NOTICE

5. Variance Request – Ground Sign Height, Number of Wall Signs – Gas Station Pump Sign Area – 720 S. Clinton Street

**CITY OF GRAND LEDGE
STAFF REPORT
VARIANCE REQUEST**

LOCATION: 720 S. Clinton Street

Ground Mount Signage Height Variance for two signs:

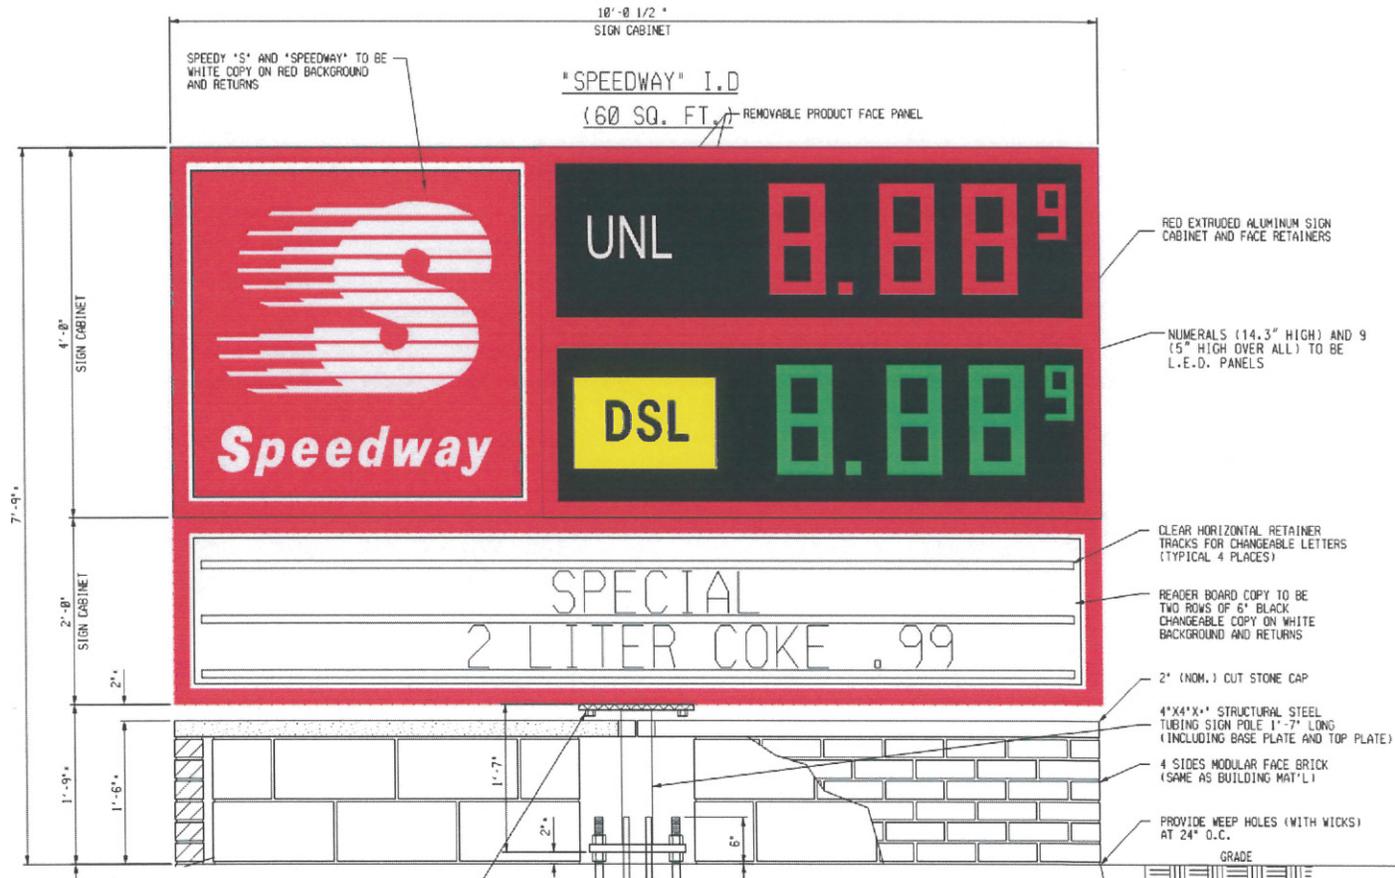
The current sign ordinance regulating the allowable height and square footage for ground signs in the “B-1” Highway district went into effect on January 1, 1997. Sign that date, all new signs within the “B-1” district are in compliance with the sign ordinance. There have been a few variance requests for larger and taller ground signs in this district, most of which occurred within a few years after the ordinance went into effect, and all of which have been denied. This included requests from Rite Aid, Family Video, Walgreens and Auto Zone. Since there is nothing unique about the subject property that would warrant a variance to allow a taller ground sign, approval of such a variance would set a precedent for future requests to vary the sign ordinance. Such a precedent would render the existing sign ordinance provision regulating ground signs in the “B-1” district meaningless, thus opening up the ordinance for a sign pattern that is completely contrary to the intent and purpose of the ordinance as quoted above.

There is no evidence that the requested variances will adversely impact property values in the area. However, since there is nothing unique about the subject property that would warrant relief from the sign ordinance relative to the additional ground sign height, approval of that variance would result in future request to permit taller ground signs than what is permitted by ordinance, thus creating an environment that is contrary to the intent and purpose of the ordinance regulating ground signs.

In order to preserve an ordinance standard, there must be something sufficiently unique about a particular parcel of land to differentiate it from a claim that could be made for most other parcels of land. Correspondingly, the variance must be based on more than a matter of mere preference. In this case, there is nothing unique about the subject property that sets it apart from any other property in the “B-1” Highway Service District that would warrant a variance to the height limitation for a ground sign. The site is perfectly rectangular, complies with the minimum lot width requirement, there is no uneven topography on the site or any other unique factor that would make compliance with the ordinance provision impractical for the applicant. Furthermore, since the property is a corner lot with more than 200 feet of frontage on each street (Clinton & Saginaw), it is permitted 2 ground signs so that it has adequate identification from all directions on S. Clinton and E. Saginaw Highway.

This variance is to allow for an exception to the height restriction on the ground mount signage permitted in section 220-78.J.1.b of the City of Grand Ledge Zoning Ordinance. The ordinance requires ground mount signs to be a maximum of 6' in height. The standard 60 SF Speedway ground signage panel is 6' tall and the masonry base of the sign is 1'-9" tall for a total of 7'-9" in height.

Staff further recommends denial of the variance request of 1 foot, 9 inches to the height limitation for a ground sign at 720 S. Clinton Street, based on the findings of fact detailed in this staff report.

Dispenser Graphic Variance:

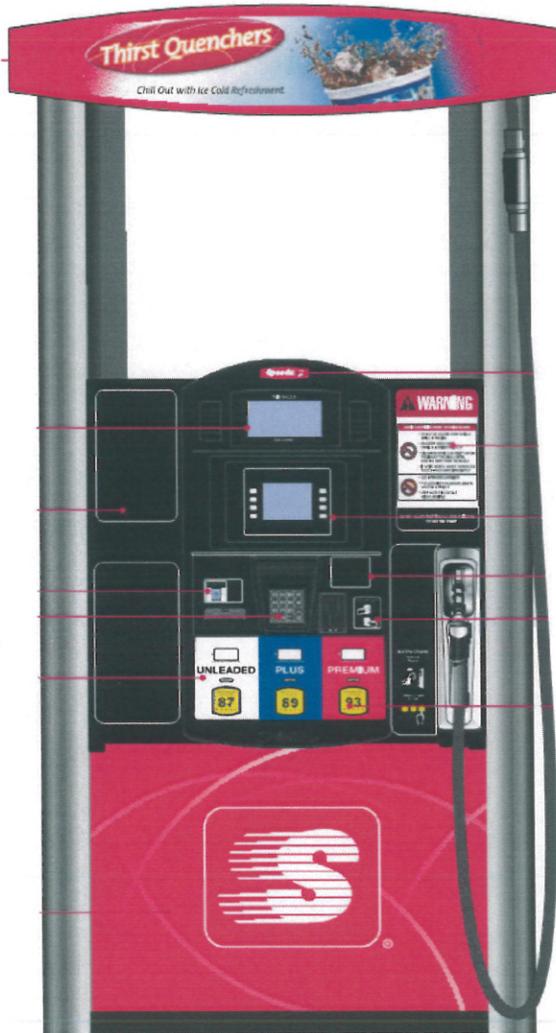
With respect to the request for an additional 6.5 square feet of signage on the pump islands, there is nothing unique about the subject property that would warrant a variance from this standard. However, the signs will be located far enough away from the roads so that they are not readable or even noticeable except to motorists already on the site. Since the additional square footage will not be contrary to the intent of the ordinance, which is to limit signage in order to reduce visual clutter along the streetscapes, denial of the variance would cause an unnecessary hardship for the applicant.

With respect to the variance for additional sign area on the gas pumps, while there is nothing particularly unique about the property that represents a practical difficulty in complying with the ordinance, approval of the variance would not be contrary to the intent and purpose of the ordinance since the signs are only visible to customers already on the site. In other words, it will have no effect on the “physical appearance” of Grand Ledge.

This variance is to allow for an exception to the permitted accessory signage per gasoline pump. Per section 220-78.J.4 of the City of Grand Ledge Zoning Ordinance automobile service stations shall be permitted to provide one additional accessory sign per gasoline pump, affixed to each pump and not more than two square feet in area. Speedway is requesting to allow an 8.5 sf valance sign (85.5" x 14.25") on the top of the dispenser and a 10.5 sf door skirt (54" x 28") sign on the bottom of the dispenser.

Staff recommends approval of the variance request by Speedway, LLC for a variance of 2 to the allowable number of wall signs and 6.5 square feet to the allowable area for signs located on the gasoline station pumps at 720 S. Clinton Street, based upon the findings of fact as detailed in this staff report, and to give immediate effect to the approval of the variances at 720 S. Clinton Street, as necessary for the preservation of property and hereby certified on the record.

SIGNAGE PLAN & DETAILS
NEW BUILD
730 S CLINTON STREET
EATON COUNTY
GRAND LEDGE, MI

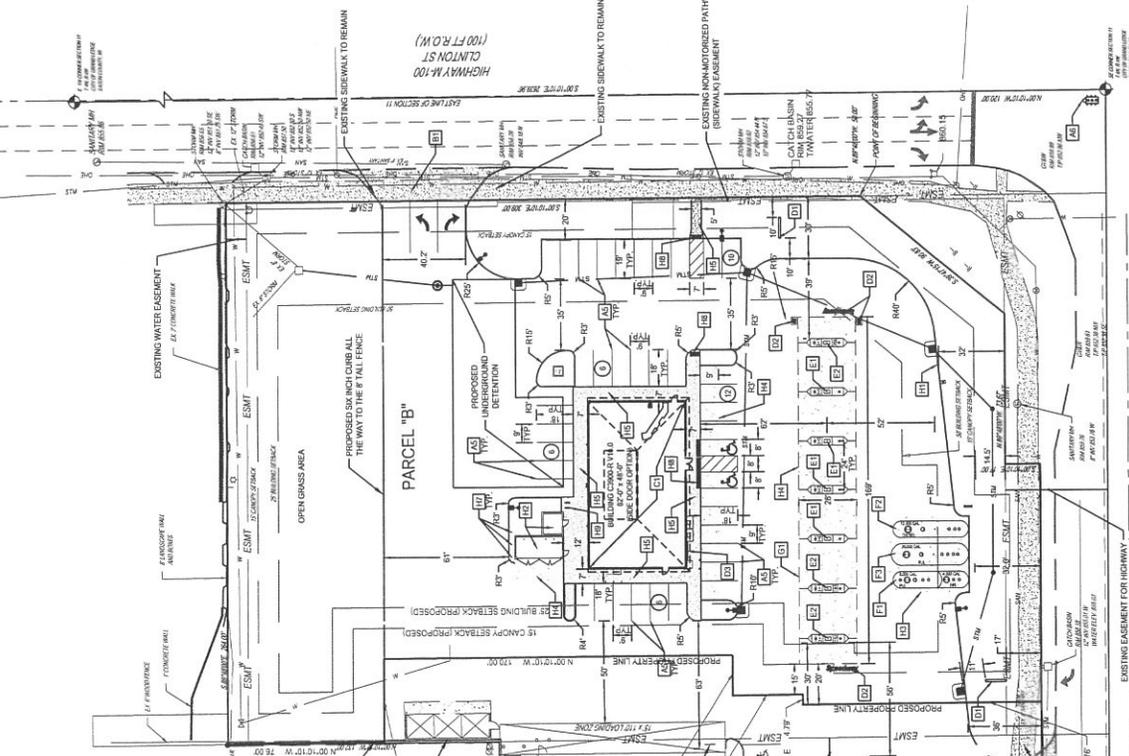
In this case, the ordinance allows one wall sign on each wall with road frontage so that the business is easily identifiable to motorists. The future Speedway Station will have frontage on both Saginaw and S. Clinton which means that one wall sign is permitted on the east wall of the building/canopy and one on the south wall/canopy. Through the use of joint driveways, parking lot connections, shared storm water facilities, etc., the future Speedway station is designed to function as one site with the future retail building to the west and even the Cedar Village Shopping Center to its west. As evidenced by the attached site plan, while the

west building/canopy façade will not have “road frontage” as required by the ordinance for a wall sign, it will face the internal drives which essentially function as private roads. In addition, the site is located a great distance from the north property line of the site and traffic enters the site from a drive north of the building on S. Clinton Street. Therefore, unlike most businesses, the Speedway station will have customers accessing it from all directions of the site which make the additional wall signs necessary from a customer identification standpoint and not contrary to the intent of the ordinance.

As described under item “a” above, the circumstances of the request for additional wall signs are based on the new Speedway building being part of a larger development, all being accessed by two driveways with interior access drives and parking lot connections providing the primary means of access to the businesses. Although there are a couple of fairly similar situations in the city, the compilation of all of the factors surrounding this request for additional walls is unique to the property in question.
